Re: Harold D. Thompson Regional Water Reclamation Facility (HDTRWRF)
Lower Fountain Metropolitan Sewage Disposal District (LFMSDD)

Submittal No.:	06100-003
Date of Submittal:	September 13, 2012
Title:	I-Joists for the Operations Building
Specification Section:	06100 – Carpentry
Manufacturers:	NDF Construction, Inc.

Submittal : I-Joist for Operations Building

CHECKED BY: DATE: 10 SEPT 12
DRAWN BY: M.L.
SHEET: 1
OF: 2

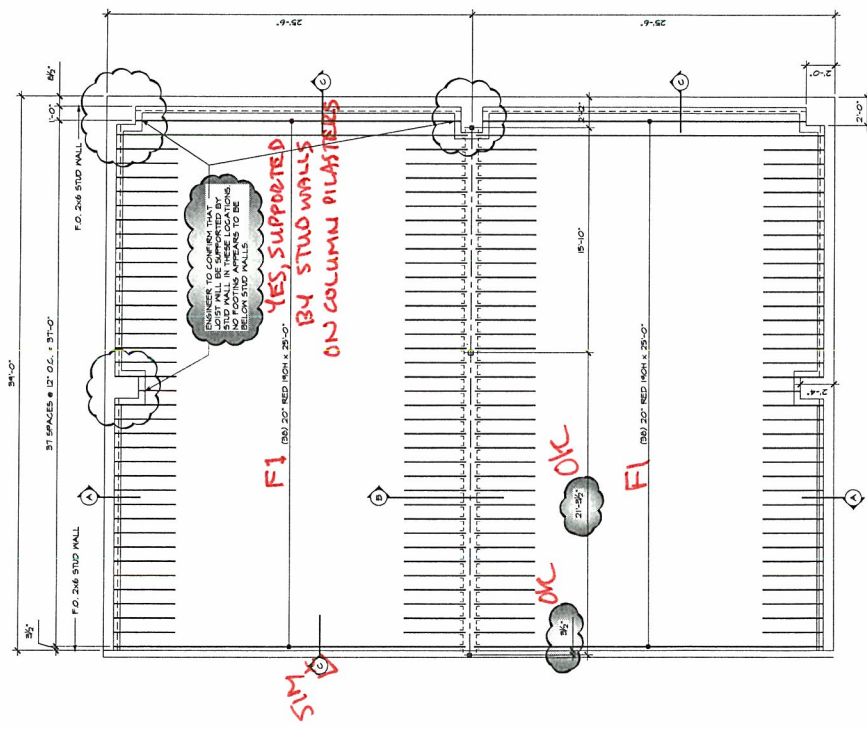
JOIST LAYOUT DOES NOT
MATCH DRAWING. ALL
MECHANICAL PENETRATIONS
SHOWN IN SECTION.

OK
